VERMONT YANKEE NUCLEAR POWER STATION

Amendment No. 87
License No. DPR-28

ATTACHMENT TO LICENSE AMENDMENT NO. 87

SAFETY EVALUATION BY THE OFFICE OF NUCLEAR REACTOR REGULATION

Organizational Chart

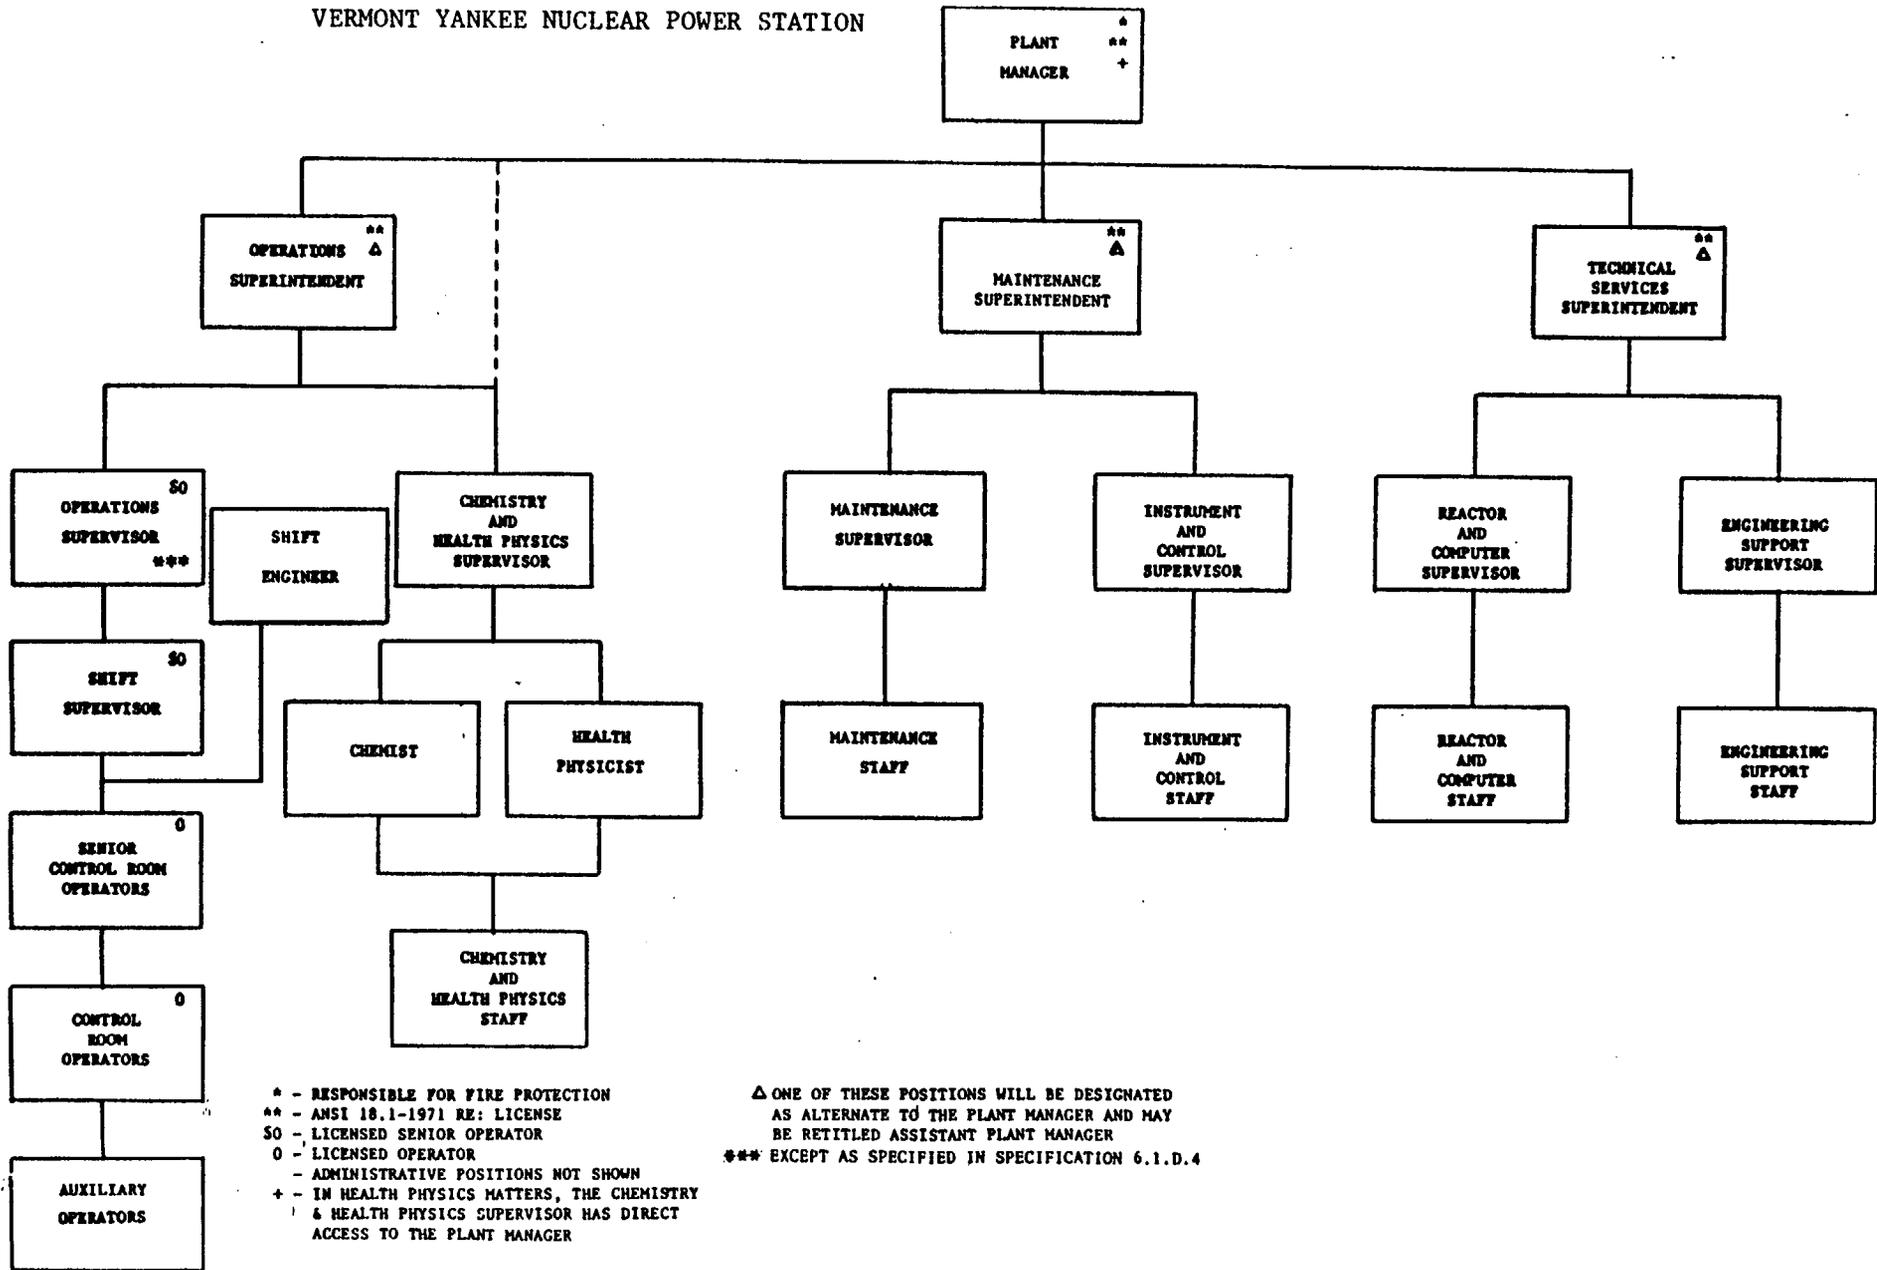
Δ ONE OF THESE POSITIONS WILL BE DESIGNATED AS ALTERNATE TO THE PLANT MANAGER AND MAY BE RETITLED ASSISTANT PLANT MANAGER
 *** EXCEPT AS SPECIFIED IN SPECIFICATION 6.1.D.4
